Development Special Use Permit #2025-10015
Special Use Permit #2025-00048
2051 Jamieson Avenue – Carlyle Block B Conversion

Application	General Data	
Project Name: Carlyle Block B - Office to Residential Conversion	PC Hearing:	November 6, 2025
	CC Hearing:	November 15, 2025
	If approved, DSUP Expiration:	November 15, 2028
	Plan Acreage:	0.9 acres (39,017 sf)
Location: 2051 Jamieson Avenue	Zone:	CDD#1 / Coordinated Development District #1
	Proposed Use:	Multi-unit Residential
	Dwelling Units:	181 (retail option) 187 (all residential option)
	Gross Floor Area:	214,228
	Net Floor Area:	189,422
Applicant: Red Fox Development, represented by W. Kenneth Wire, attorneys	Small Area Plan:	Eisenhower East Small Area Plan
	Historic District:	N/A
	Green Building:	Complying with 2019 Green Building Policy
Purpose of Application: The applicant requests approval of a Development Special Use Permit amendment and a Carlyle Special Use Permit amendment, to construct an addition and convert an existing office building into an 187-unit multi-unit residential building, and with associated site improvements.

Application and Modifications Requested: - Development Special Use Permit amendment to constru

Figure 1: North Facing Section

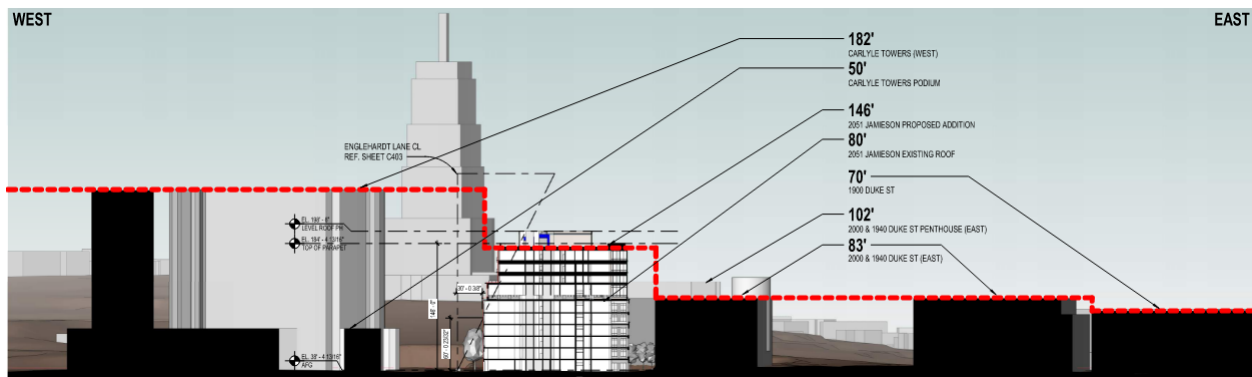
The average height of buildings in the immediate four-block area around the site is 138 feet, only eight feet less than the proposed height. The design appropriately balances the project's functional need to achieve a viable residential unit count with sensitivity to the surrounding context. The proposed massing and height were shaped to fit within the existing skyline, minimizing visual impacts and avoiding abrupt transitions between structures of different scales. In an effort to further limit impacts the applicants proposal steps back 11.4 feet on the top three floors on the western elevation closest to Carlyle Towers.

Block B, Page 8 of 8

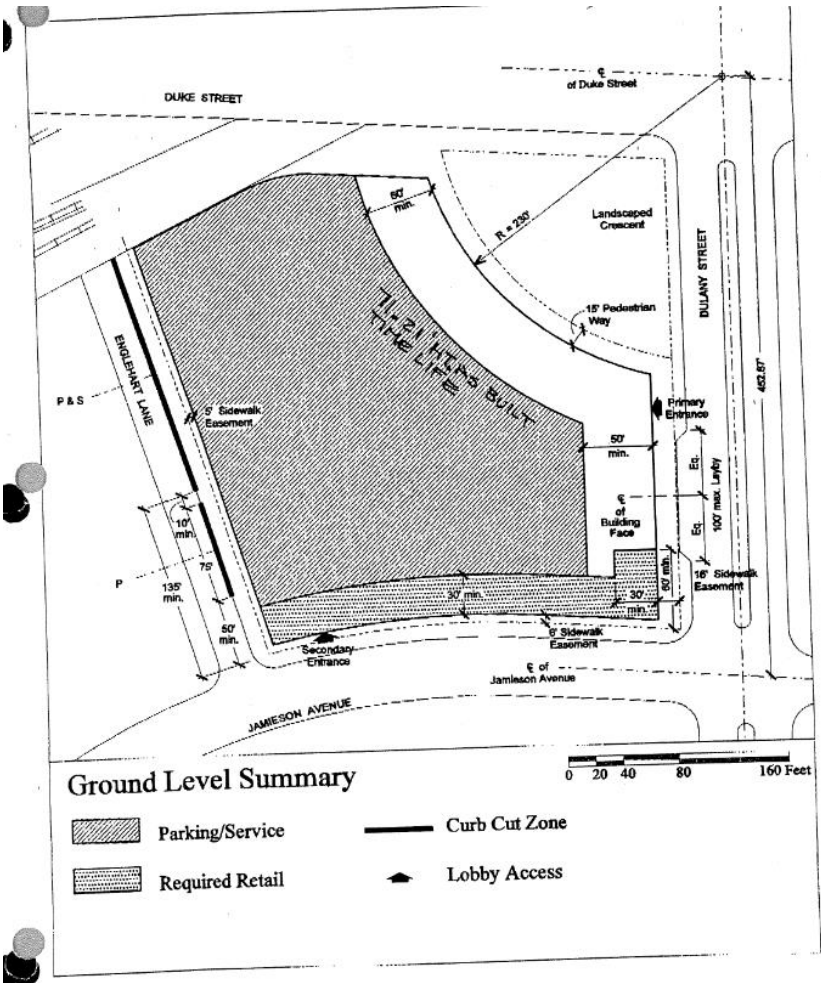
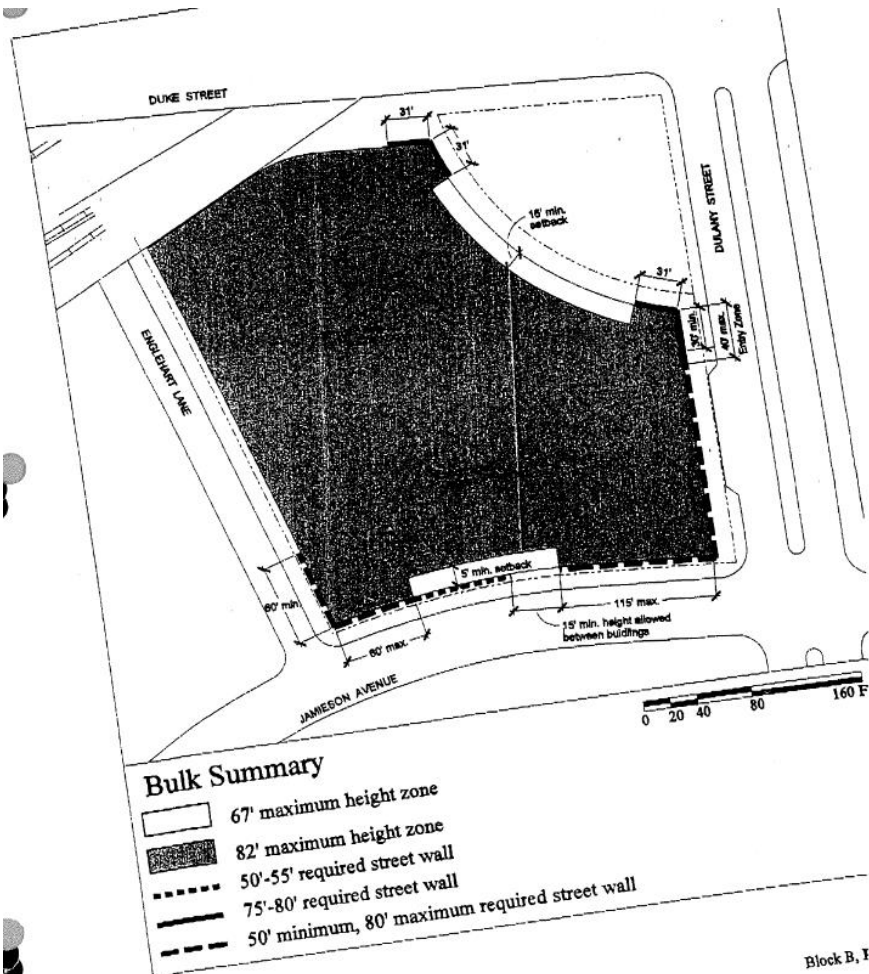
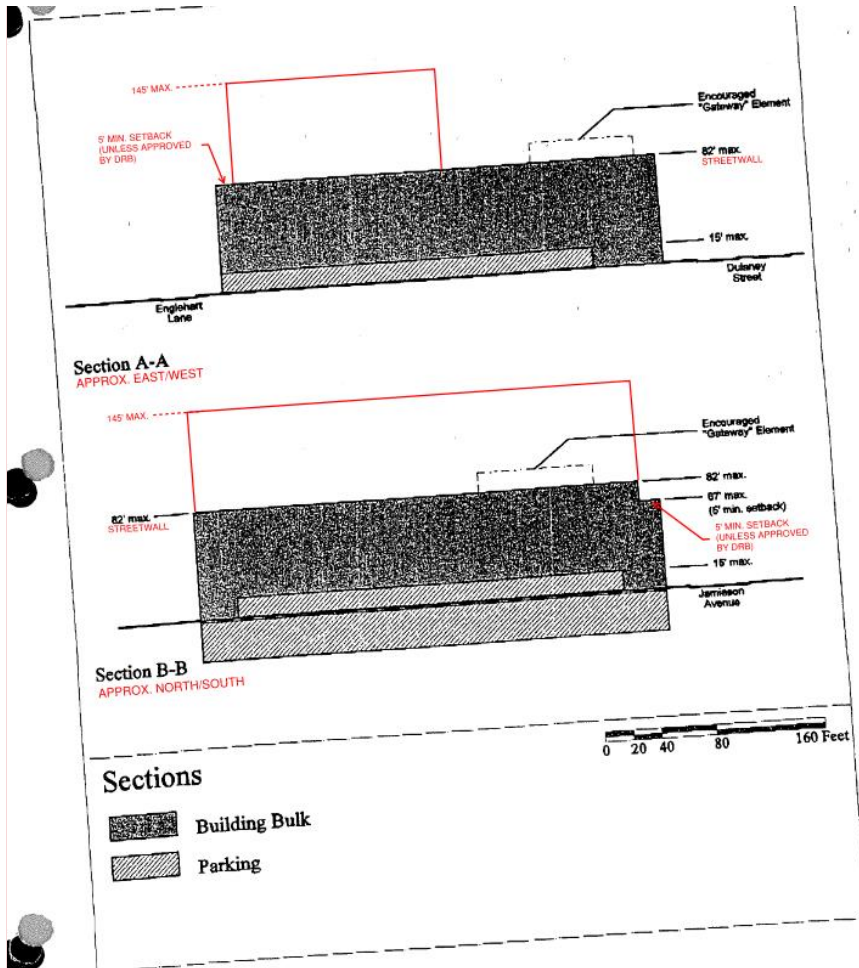
Commented [AP1]: TO APPLICANT TEAM: Change max height in the max height in the illustration on this page to 146 feet instead of 145 feet.

Comparative Height

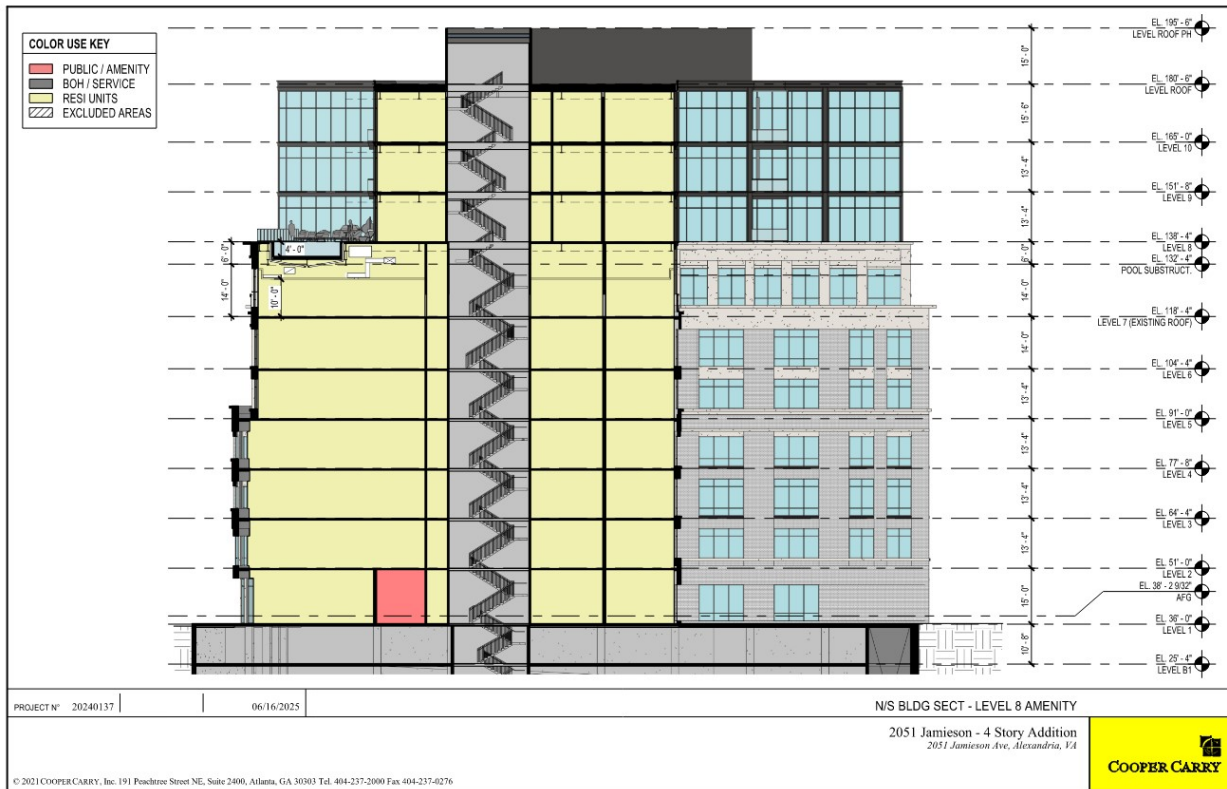
The applicants' architects and engineers stamped plans are certifying the addition is feasible. Generally speaking, we rely upon the expertise of our colleagues in Code Administration during the building permit review to ensure that all applicable state and local building code requirements are met.
